February 9th, 2026

Mr. Alan Sielaff
Assistant Town Planner
Town of Fraser
PO Box 370
Fraser, CO 80442

On behalf of Grand Park Development, Terracina Design is submitting a revised Final Plat & FPDP for Grand Park West Mountain Filing No. 1 Planning area 10W.1 & 11W to address the comments dated January 26, 2026. See responses below.

SITE PLAN
 DECEMBER 18, 2025
 SHEET 5

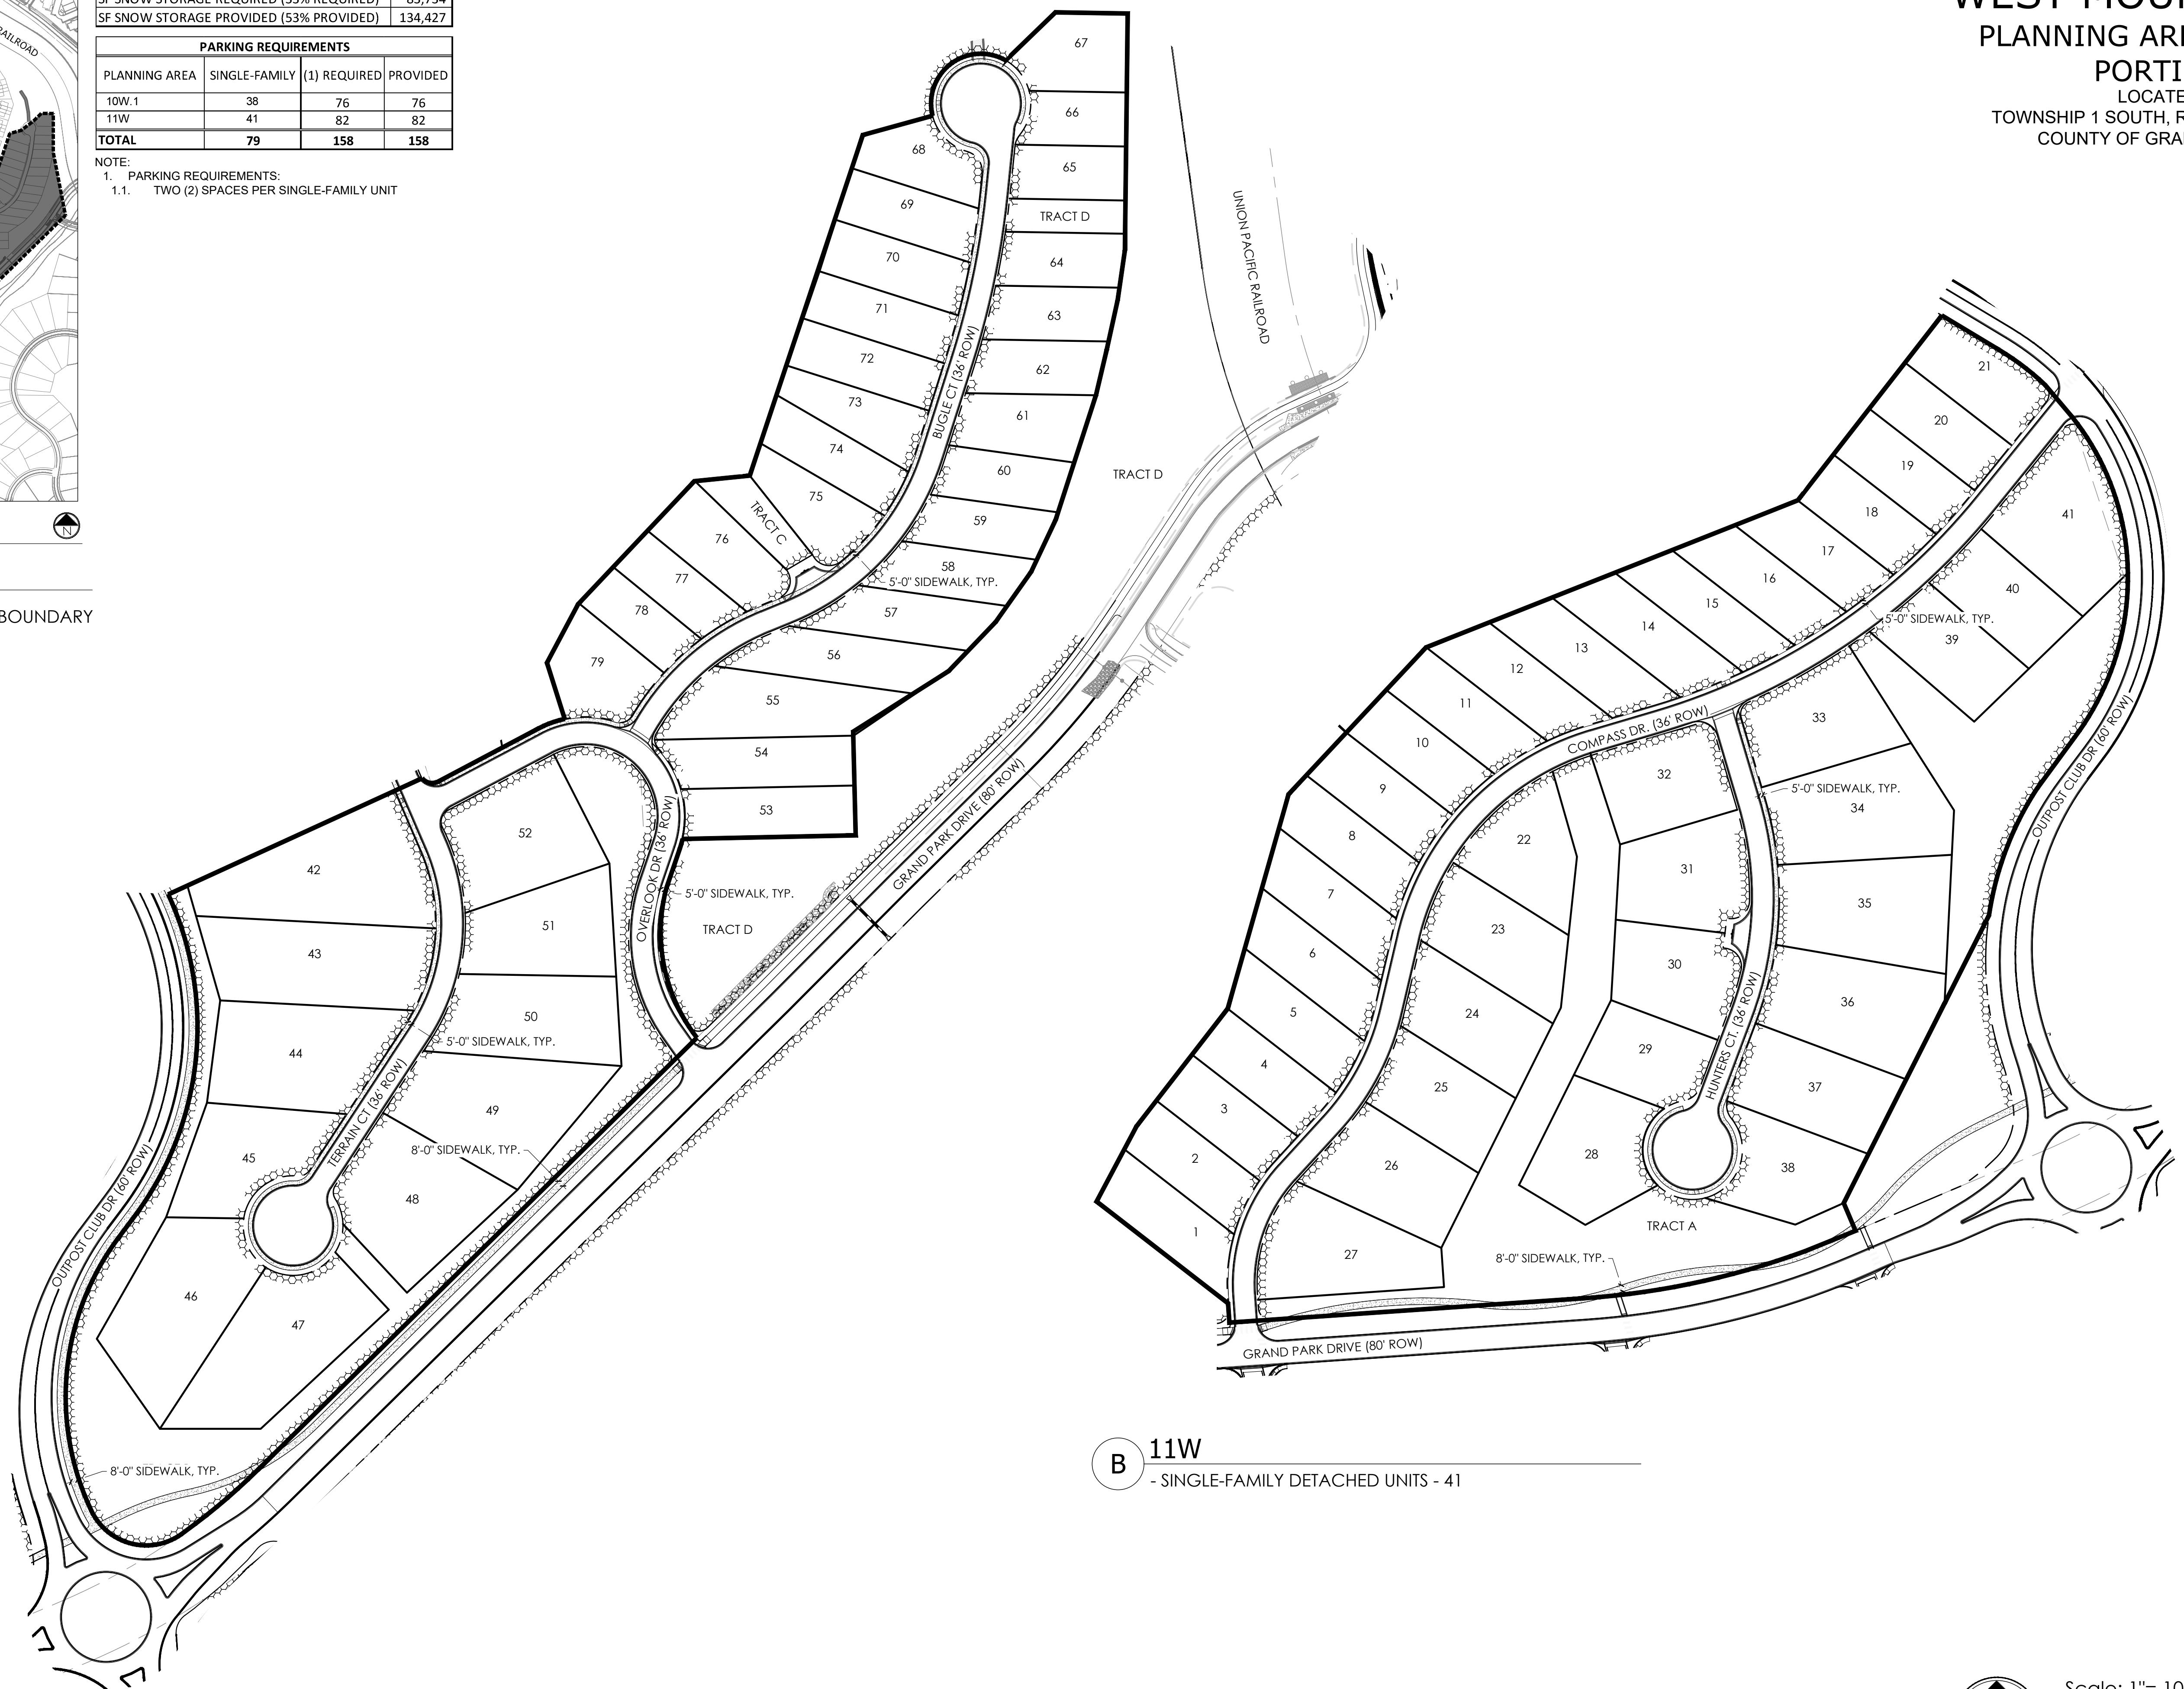
20. Ensure labeling for Planning Areas does not interfere with Lot numbers. **RESPONSE: Revised**

21. Snow storage location needs to be coordinated with utility agencies to ensure no conflicts with their easement requirements. **RESPONSE: Snow storage is designed the same as it is in all Grand Park projects and will remain the same and coordination for design and construction of utilities with the Town and other utility providers is anticipated to be the same as it always has been.**

LANDSCAPE PLAN
DECEMBER 18, 2025
SHEET 7

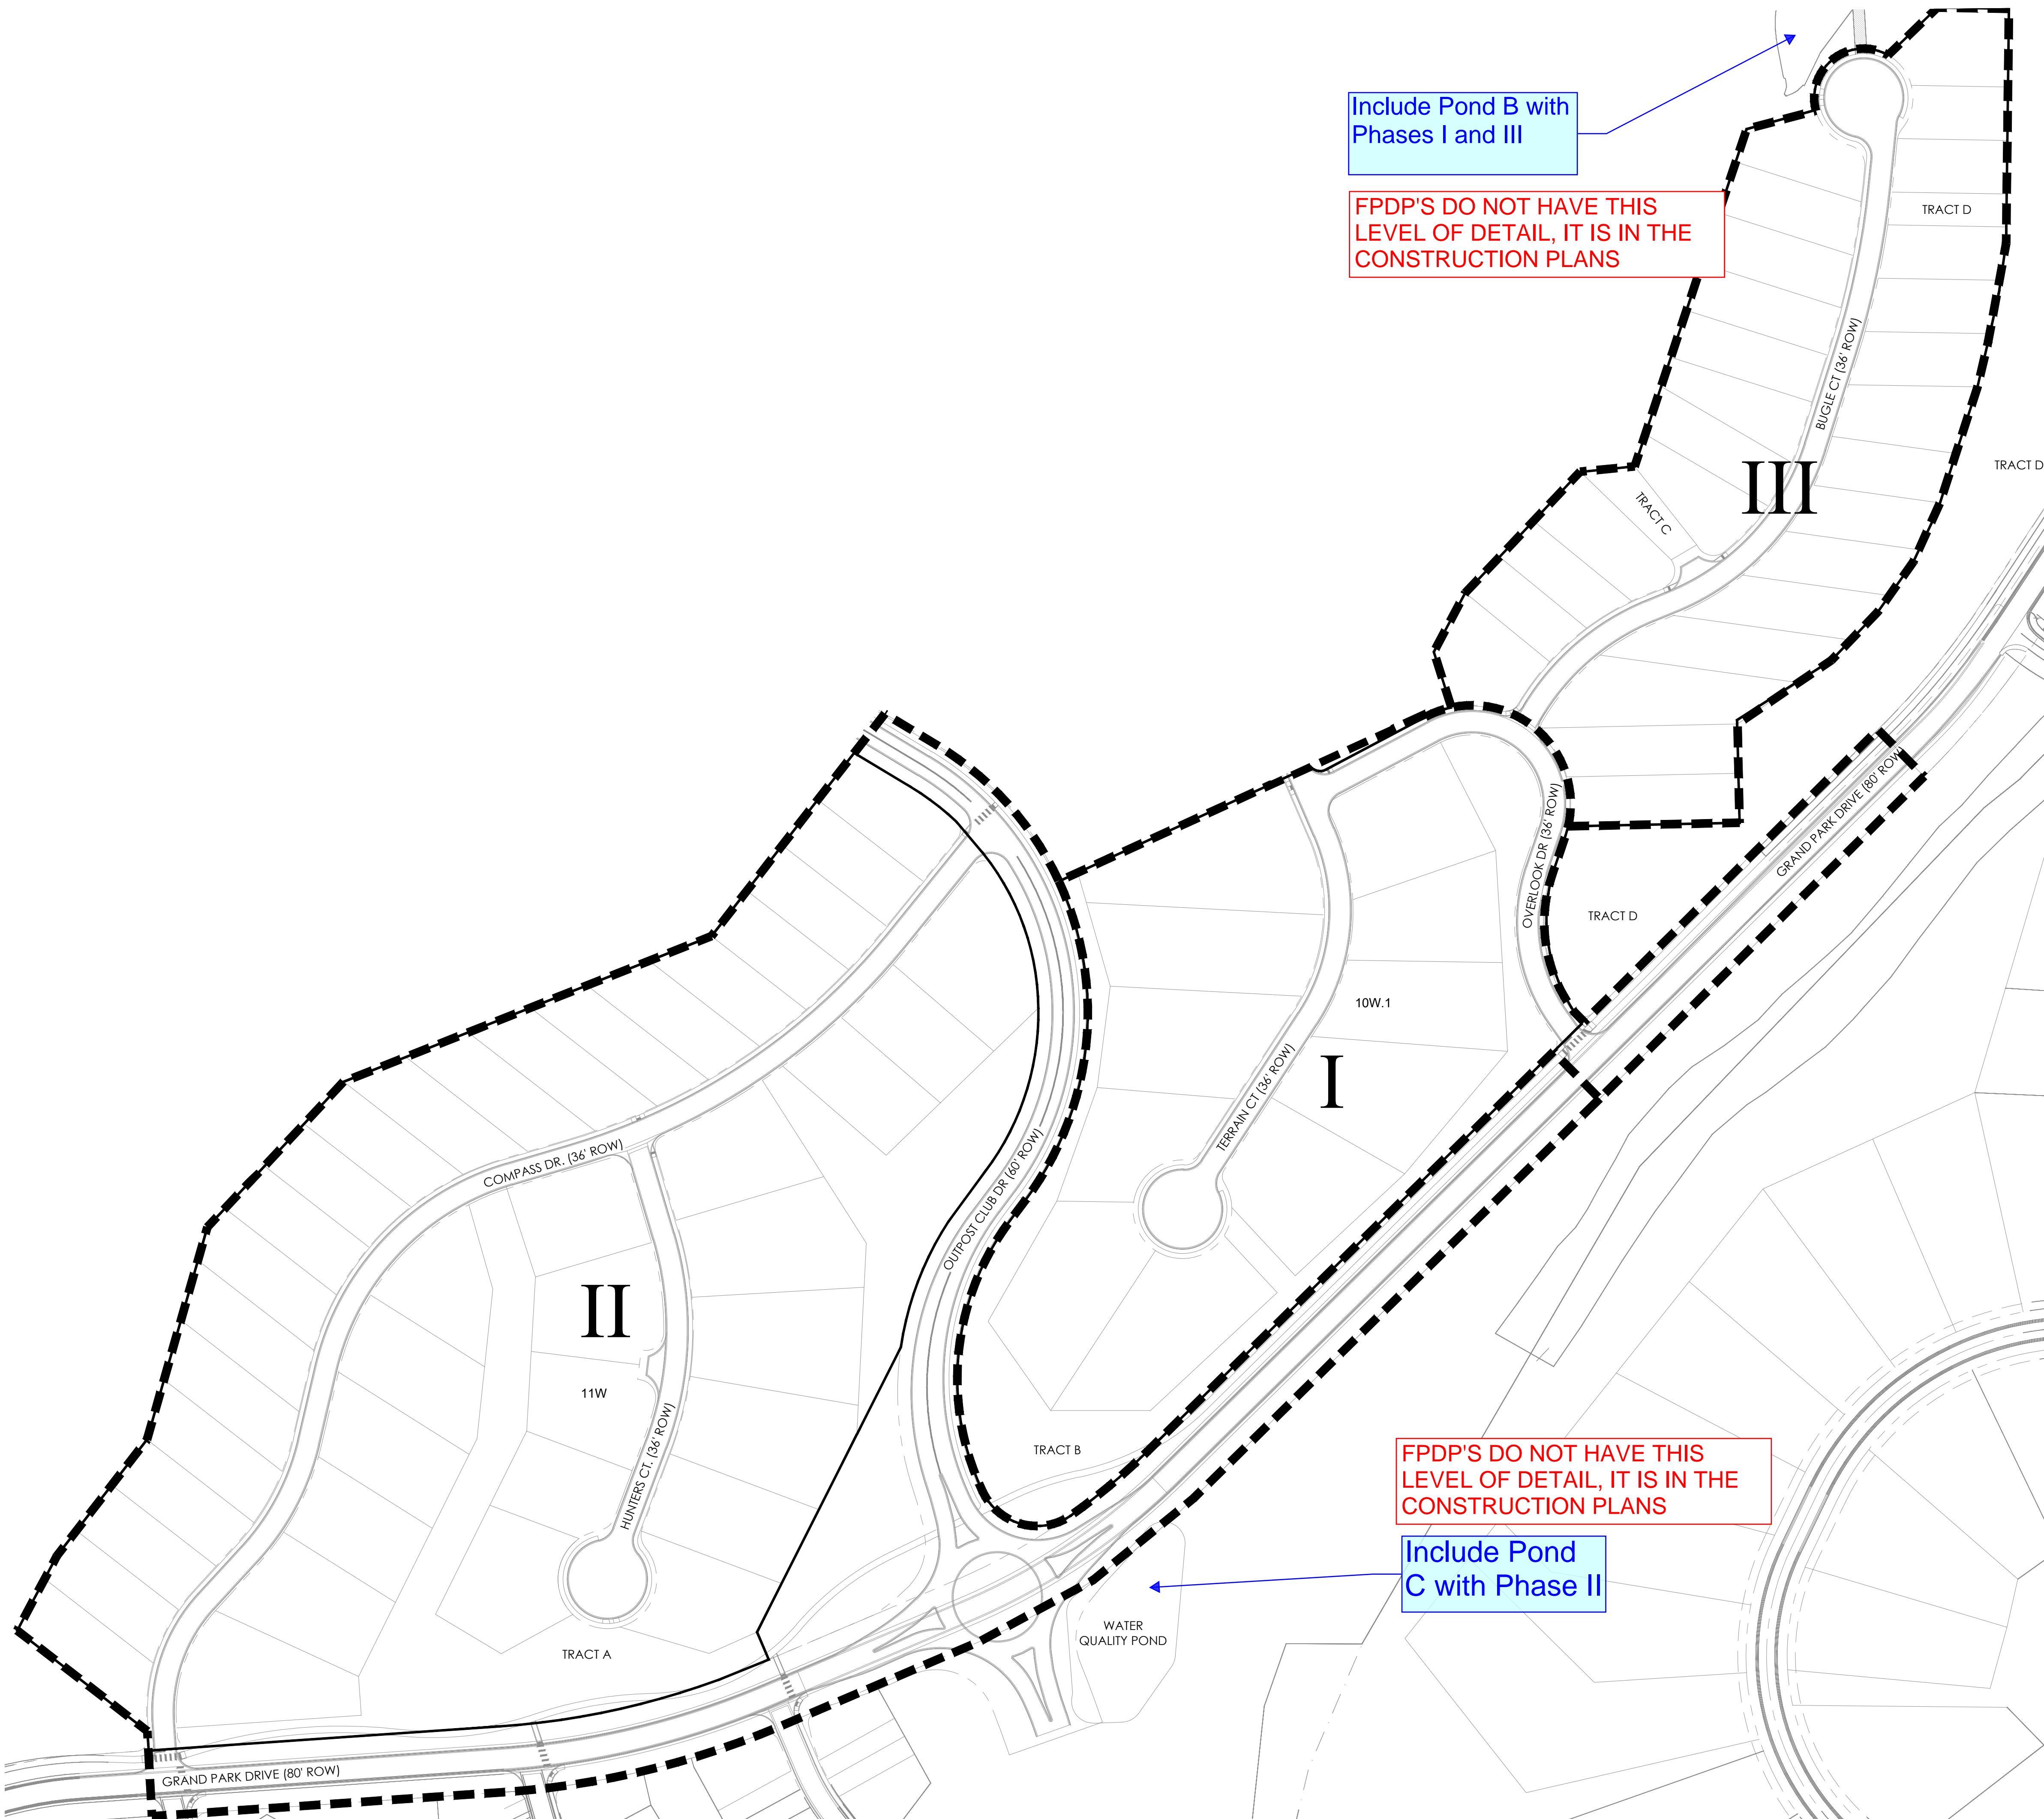
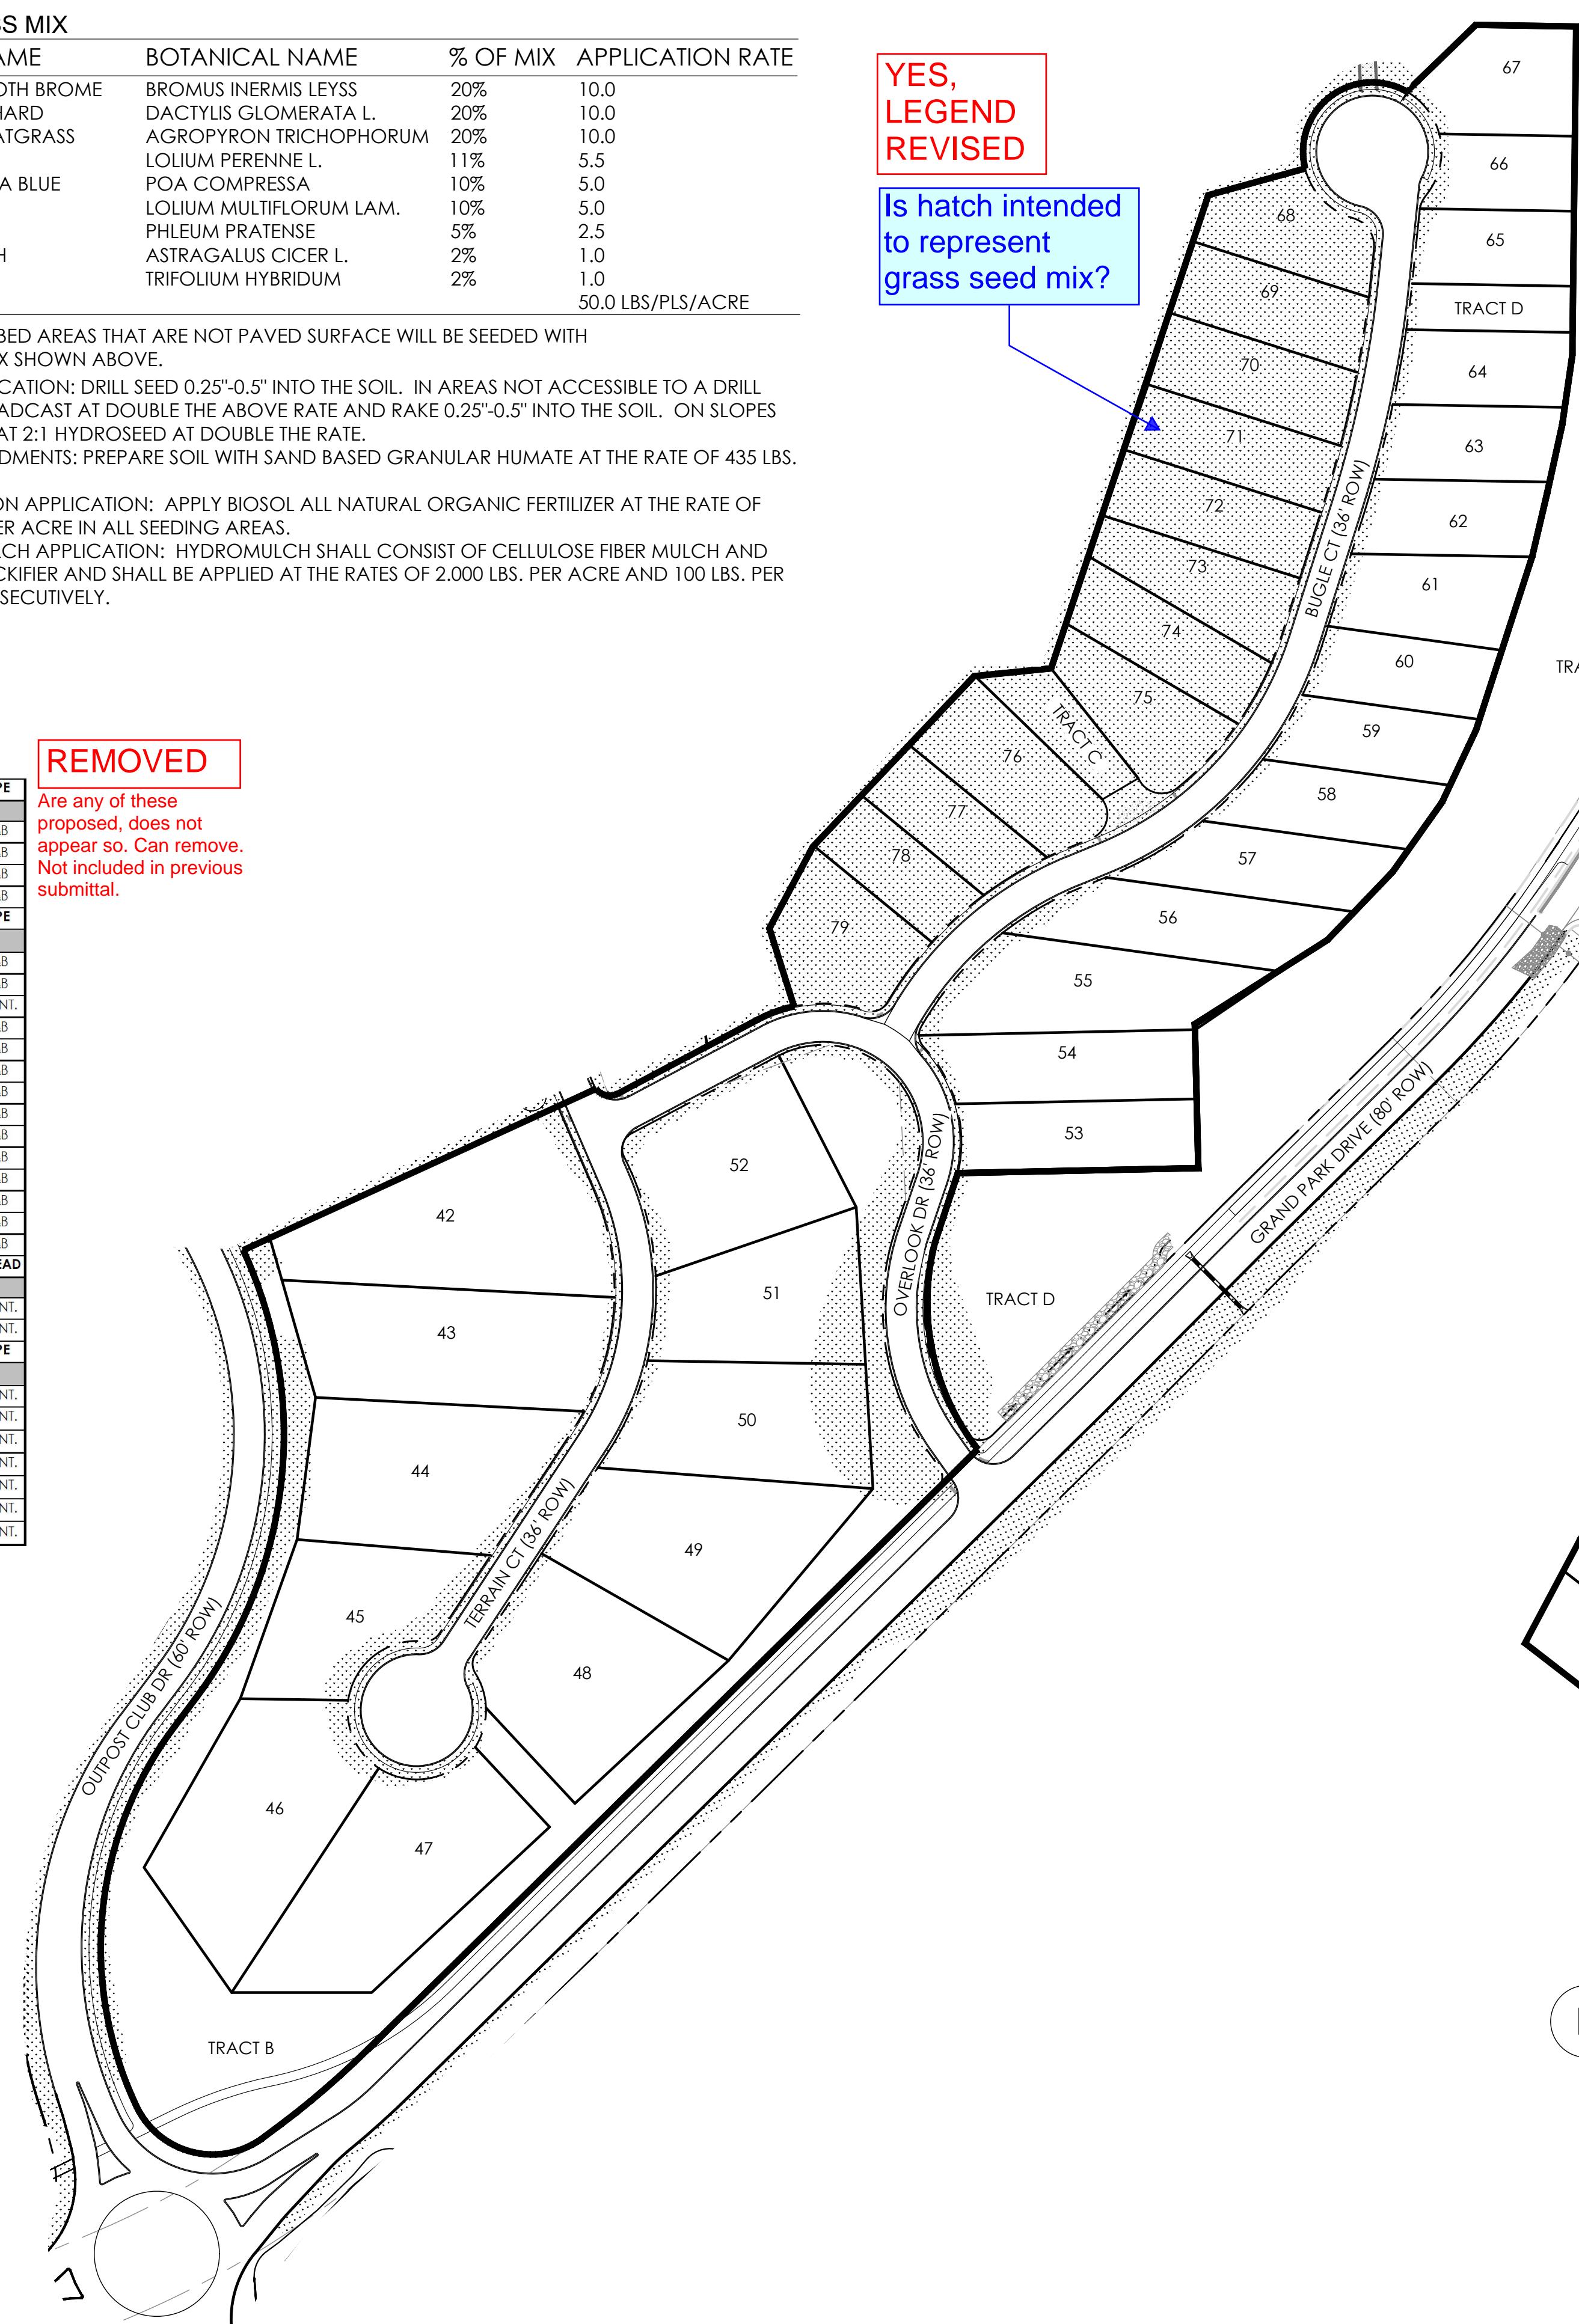
22. A tree and shrub planting list is provided, but no plantings are depicted. This list may be removed unless a specific approved planting list is proposed. Grading and Drainage Plans (Sheets 9-10) **RESPONSE: Removed**
23. Sheets 9 and 10 are missing titles. Please label as final grading plan and final utility plan. **RESPONSE: Revised**
24. Lots 27-52 are mislabeled and need to be renumbered, shifting each lot by one (Lot 26 appears to have been labeled twice). **RESPONSE: Revised**
25. Poplar Ct. is labeled as Hunters Ct. on the plat. Please ensure all street names and consistent across all documents. **RESPONSE: Revised**

Change to seed mix?

Is hatch intended
to represent
grass seed mix?
